Technical Service Bulletin

GROUP SUSPENSION	NUMBER 25-SS-003H
DATE NOVEMBER 2025	MODEL(S) SANTA CRUZ (NXT)

SUBJECT: REAR SUSPENSION CLUNK OR THUMP NOISE -
REAR SHOCK ABSORBER REPLACEMENT

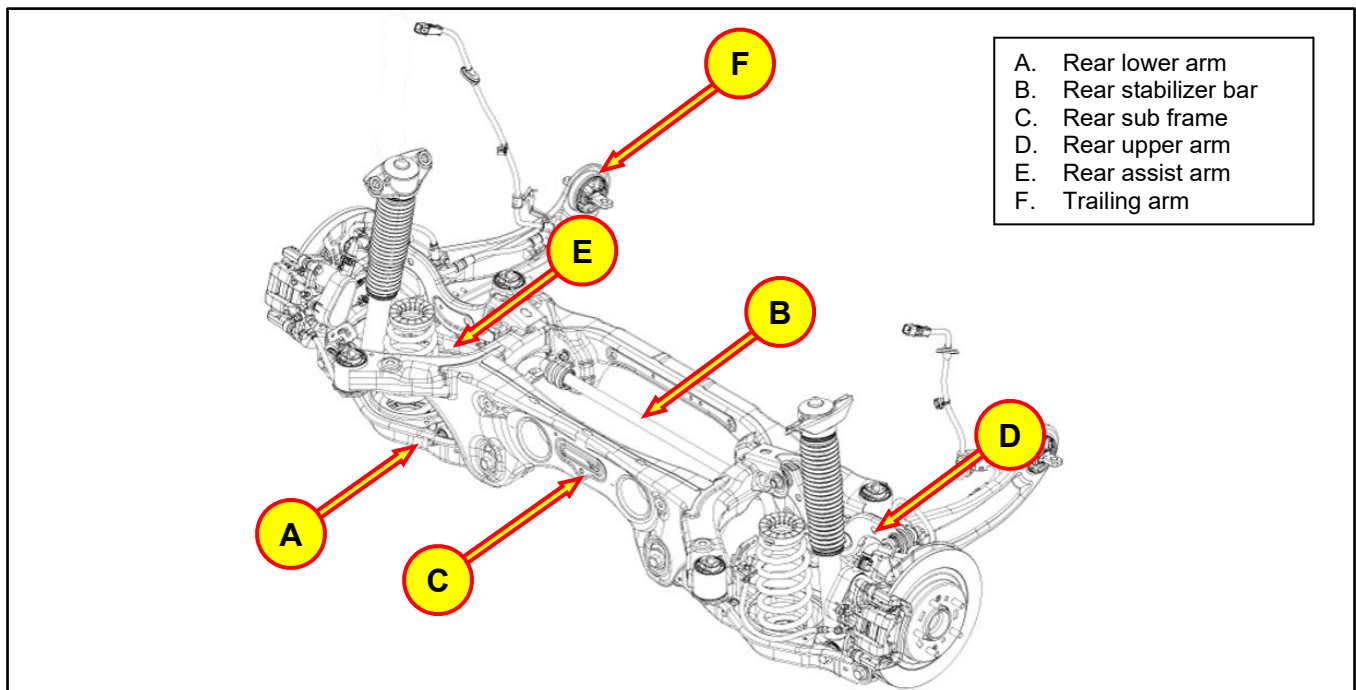
3. Visually inspect rear suspension components listed below for visible issues, damage, etc.

- If **NO** damage or visible issues are found with any components, then both rear shock absorbers (G) **MUST** be replaced. Proceed to [Shock Absorber Replacement](#).
- If damage or issues are found, diagnose and repair as necessary. Then retest for the clunk/thump noise.
 - If the noise is resolved, then the service procedure is complete.
 - **If the clunk/thump noise is still present**, then proceed to [Shock Absorber Replacement](#).

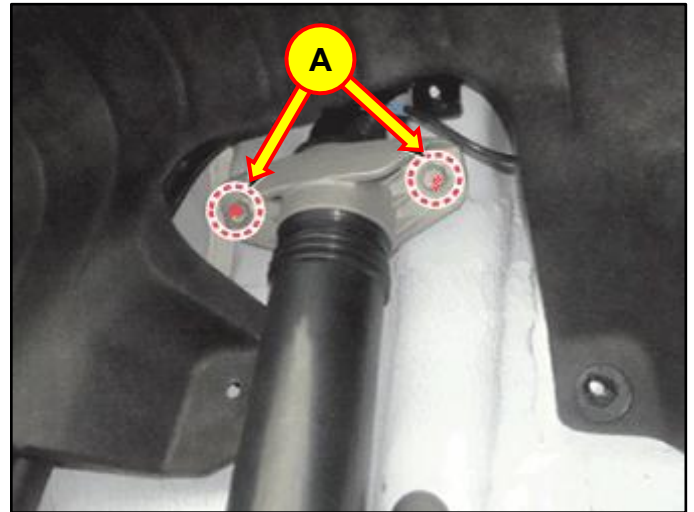
1. Replace both rear shock absorbers with the new parts.

Be sure to replace the lock nut (B) with a new part. Do **NOT** reuse it.

**Tightening Torque -
Shock Absorber Mounting Bolts (A):**

lb-ft	94
N.m	127

**Tightening Torque -
Shock Absorber Lock Nut (B):**

lb-ft	16
N.m	22
